BRACKETT AVENUE
87-LL-6 PEAKS ISLAND

Subject: Applications for permits in connection
with work on two cottages on Brackett Avenue,
Peaks Island

Subject: Application for building permit to cover strengthening of and alterations in cottage of Roy Yeargle on Brackett Avenue, Peaks Island to make a year round dwelling house

Subject: Application for building permit to
cover alterations in cottage to make of it a
year-round dwelling.

Plans for proposed alterations
of cottage on Dracutt line,
Peaks Island

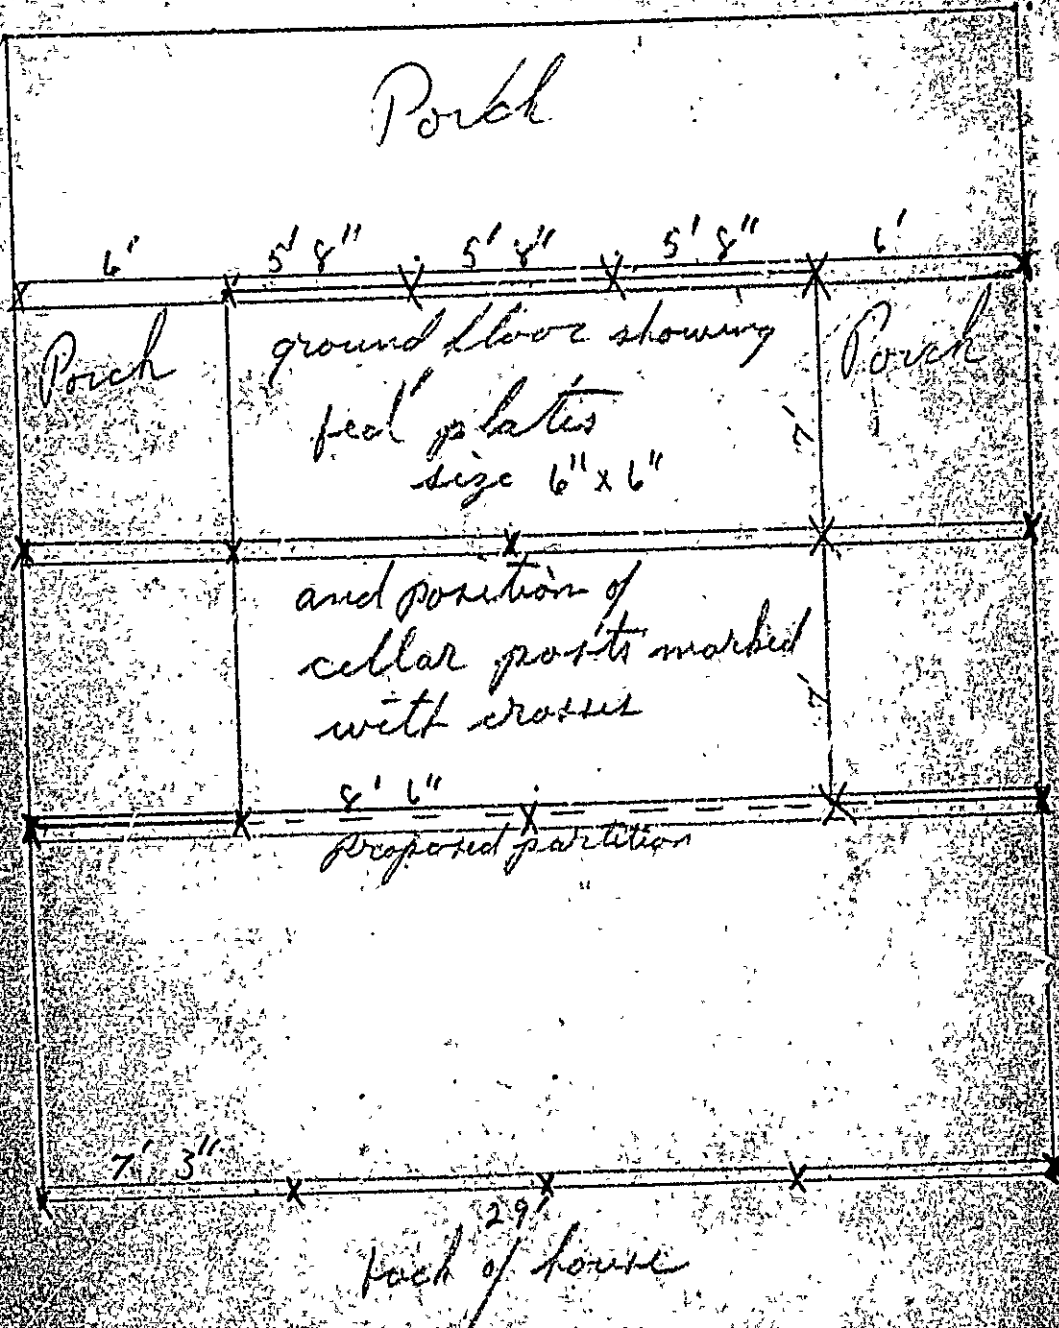
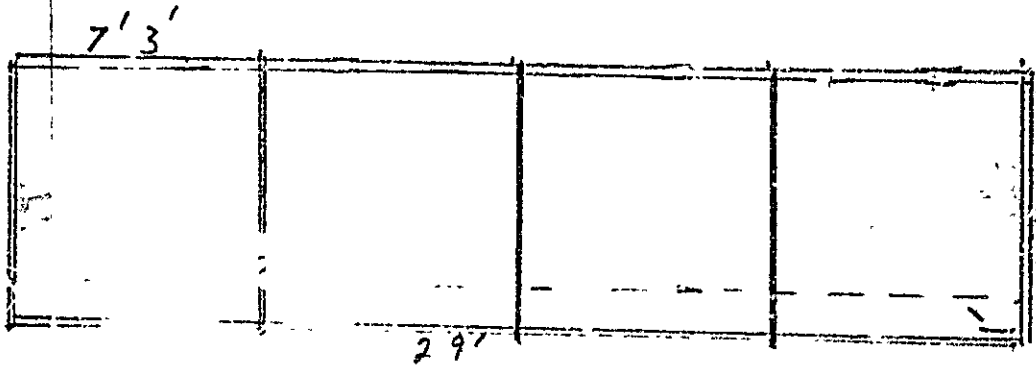
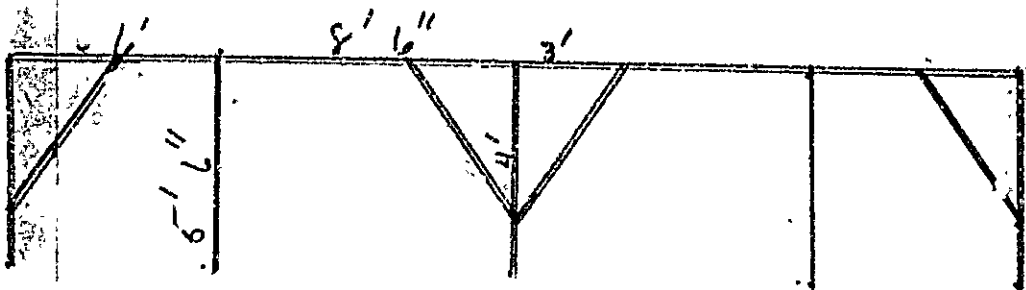
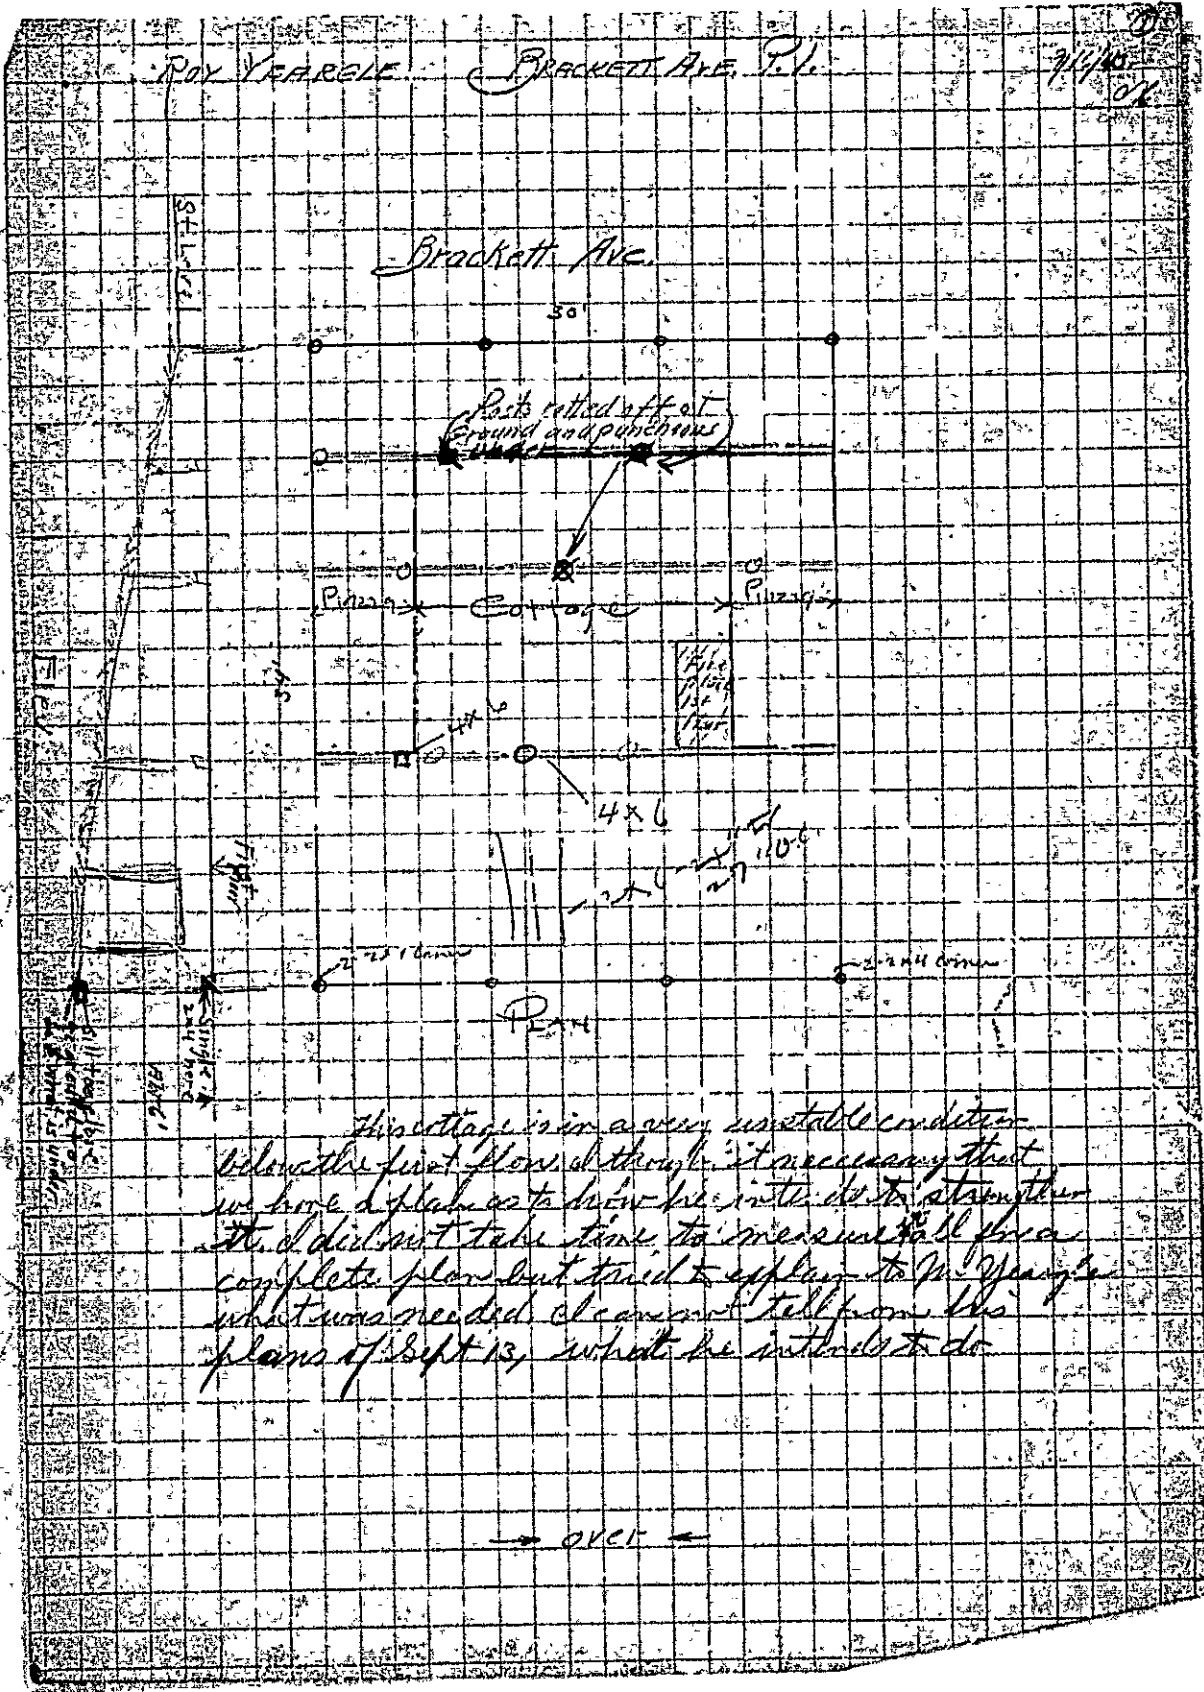
With the original permit issued to you, I sent a memorandum to you saying that I assumed that the cottage is in a good and safe, structural condition, and if not so, it would have to be made so. The office had your notice for closing-in inspection, and our inspector found the substructure of the cottage to be in a very unstable condition, - foundation posts rotted off, temporary puncheons used to support the building, etc., but no word comes from you as to what you intend to do to make the building permanently substantial and safe.

In the meantime you have applied for an amendment to the permit to cover construction of a new partition to divide the living room into living room and dining room. Before we can issue closing-in certificate, or the approved amendment, and, therefore, ^{before} it is lawful for you to do any of the work contemplated which requires a building permit, you must make a plan to scale of the frame, especially that of the first floor, the sills, the girders and existing posts, showing sizes, spacing and spans of each, and indicating all defects which are to be made permanently good, and with what material and in what manner you propose to do it.

This plan must be to scale and show the situation with sufficient clearness to one who has not seen the building and does not know your plans in advance, can understand what the situation is and what you intend. The plans which you filed with the application for the amendment on Sept. 15th are not intelligible to us, and will have to be made so. If you cannot make better, yourself, you will have to employ someone who is acquainted with the usual way of making plans to scale. It is suggested that you do that at once without further ado, and thus put the permit in line for issuance without further delay.

Alteration of cottage
(Check of plans filed 9-29-49)

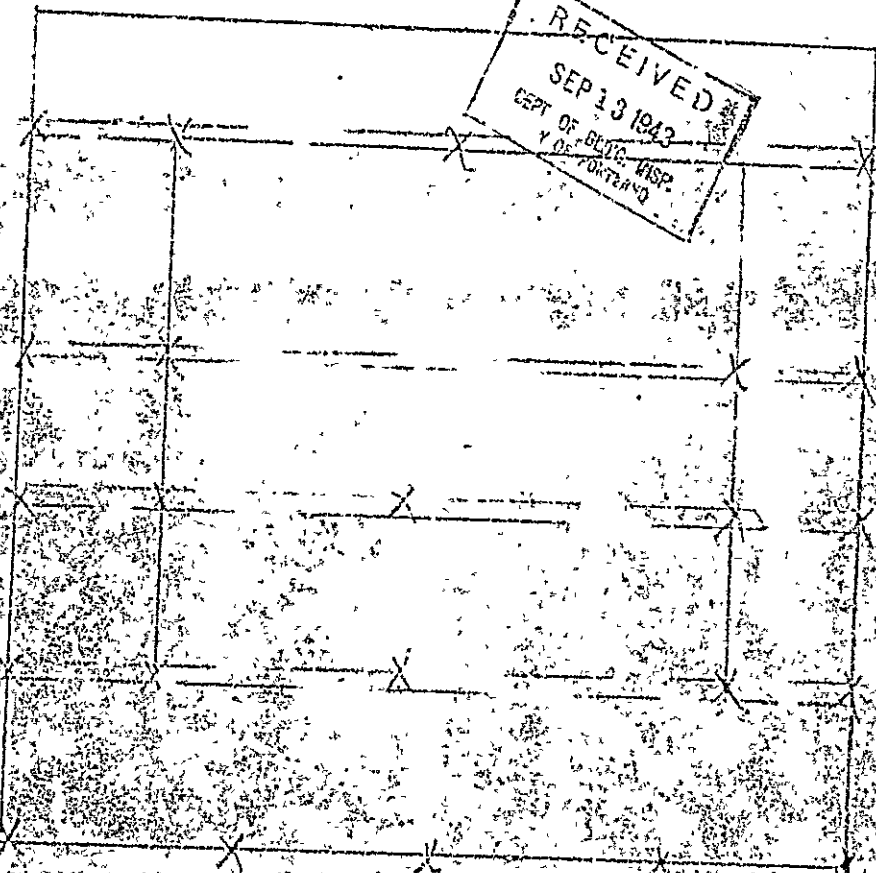
The new plans filed mean very little as to the present condition of this cottage and what Mr. Yeagle plans to do to strengthen it. I do not see that he has followed your letter of Sept 23 to any extent.

I think this man is sincere and intends to do right but the way he is going, he is getting nowhere fast. This is a very nearly 40 year old. With a good carpenter this strengthening would have probably gone along long ago. I see no other way than for him to get someone to make his plans or get a second carpenter that we can go along with it. The old he is going, the coming hard weather will catch up with him.
